Mandatory Service Bulletin

Mandatory upgrade to DMC board Rev. H with firmware V11R3b4

- This document informs about the mandatory upgrade to the DMC Board rev. H, the firmware version V11R3b4 and installation of the DMC Isolation Kit.
- For devices where the DMC board rev. H upgrade kit is installed in the field, also the chain of the transmission group needs a tension adjustment.

Figure 1: Arrestor

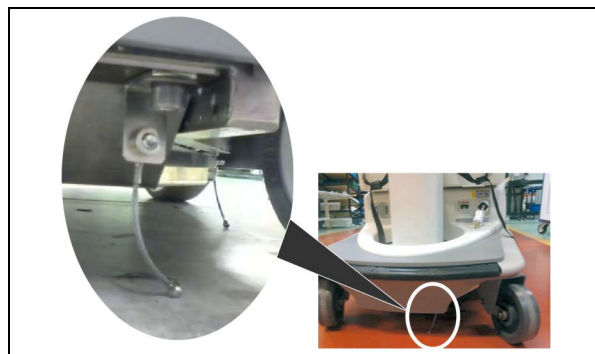
Cause If an ESD discharge occurs via the arrestor of the unit, there is a possibility that the DMC board is affected resulting in a possible unintended movement.

Solution Fix the DMC board with 4 plastic screws and isolate the board from the metallic mounting plate by 4 plastic spacers. For details refer to section 3.

Figure 4

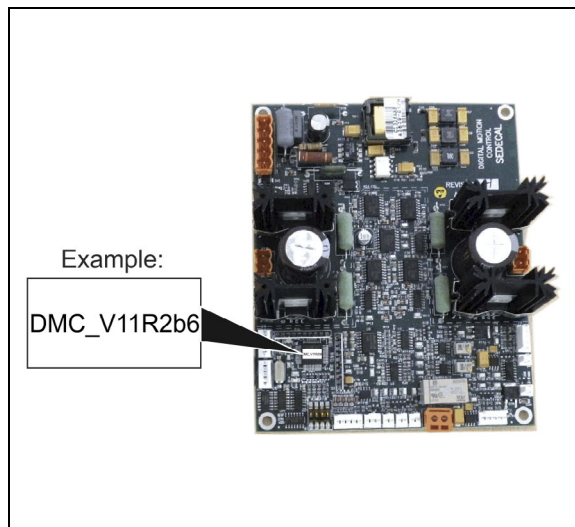
- (3) For all devices, listed in the attached MS Excel workbook to perform the “FW upgrade V11R3b4”:
Update the firmware of the DMC board to version V11R3b4 as described in the DX-D 100 / DX-D 100 Wireless - Mobile X-Ray Unit - Service Manual, section “Updating the Microcontroller”.

Write the firmware version on the board after the upgrade with a waterproof pen.

For programming of the DMC board the two clips of the DMC programming cable need to be connected to TP1 and TP2. The location of TP2 changed with introduction of DMC board rev. H. The correct location of TP2 is shown only in DX-D 100 / DX-D 100 Wireless - Mobile X-Ray Unit - Service Manual, Document ID 41600560, revision ≥ 1.4 .

During firmware update it is recommended to remove the connector for the buzzer (J15). Otherwise the buzzer will continuously beep as long as the DMC programming cable is connected between TP1 and TP2.

Figure 6

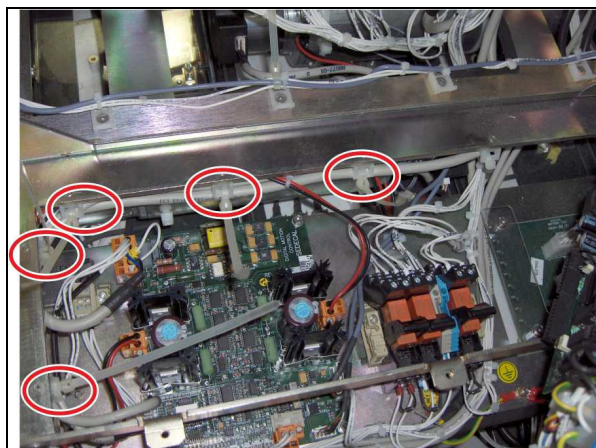
- (1) Check the encoder cable condition.
If there is stress on the encoder cables, continue with the next steps in this section.
If there is no stress on the encoder cables, continue with section 3.1.3.
- (2) Untie the tie wraps of the encoder cables.

Figure 7

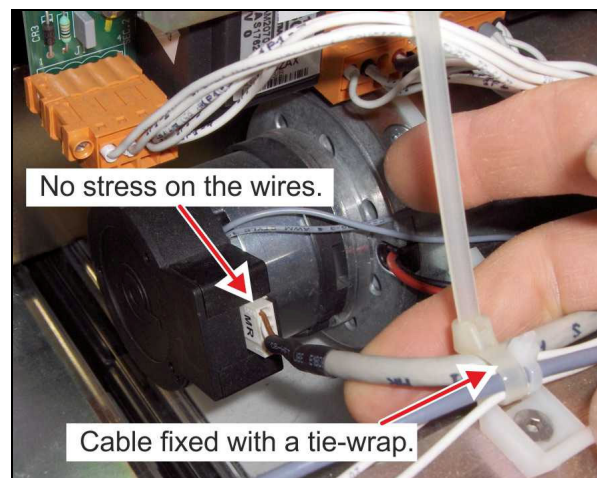
- (3) Fix the rerouted cable on the right-hand side motor encoder. Ensure, that there is no stress on the encoder wires.

Figure 8

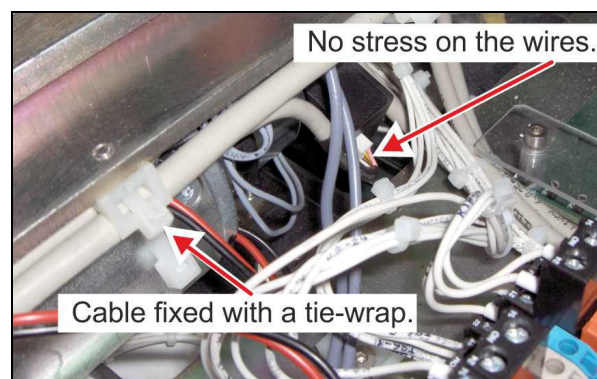
- (4) Fix the rerouted cable on the left-hand side motor encoder. Ensure, that there is no stress on the encoder wires.

Figure 9

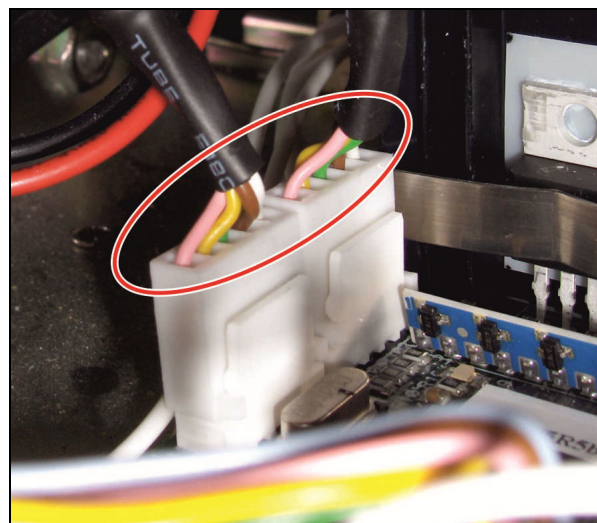
- (5) Ensure that there is no stress on the encoder wires on DMC board side. See Figure 9.
- (6) Mount new tie wraps for the rerouted encoder cables.

Figure 10

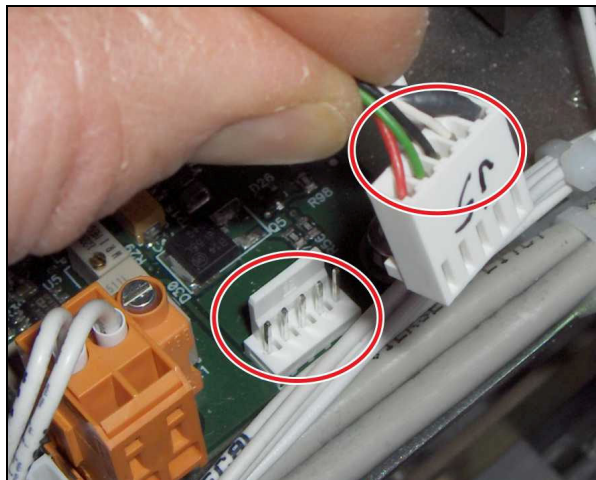
- (1) On the DMC Board, check the wires and the crimping of the wires around the J5 connector pins.
- (2) Check the pins of the J5 connector counterpart.

Figure 11

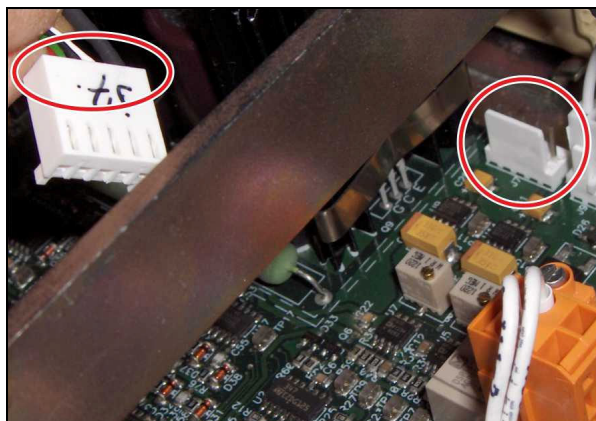
- (3) On the DMC Board, check the wires and the crimping of the wires around the J7 connector pins.
- (4) Check the pins of the J7 connector counterpart.

Figure 12

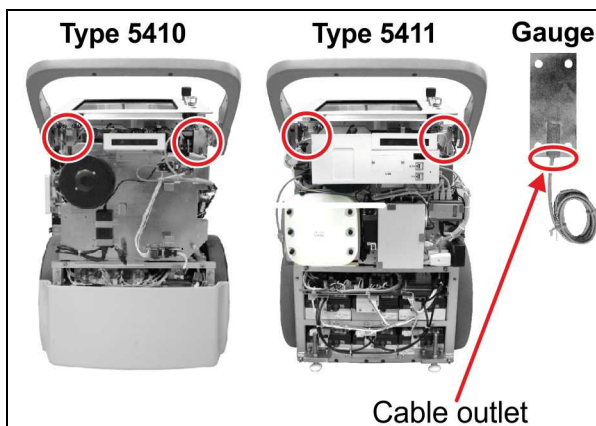
- (5) Carefully check the cable outlet of the two gauges for damages.

Figure 13

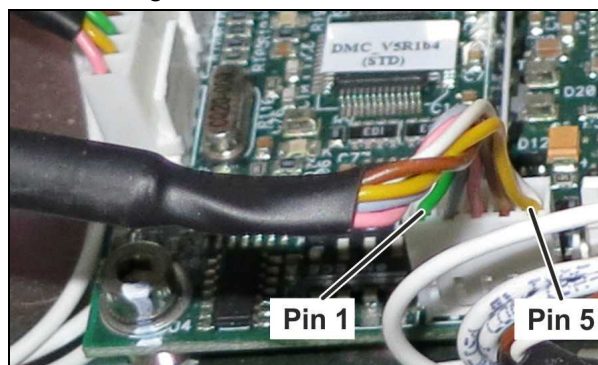
- (1) Check the status of the drive batteries (Tray 6).
Make sure the drive batteries are fully charged before further testing. If they are not, then also check the condition of the fuses and charger boards.
- (2) Disconnect the cable from J2 on DMC board.
- (3) Measure resistance at each pin (1, 2, 3, 4) against pin 5 (Common).

Normally these contacts should be open and with the button pressed the resistance should be close to 0.0 Ω .
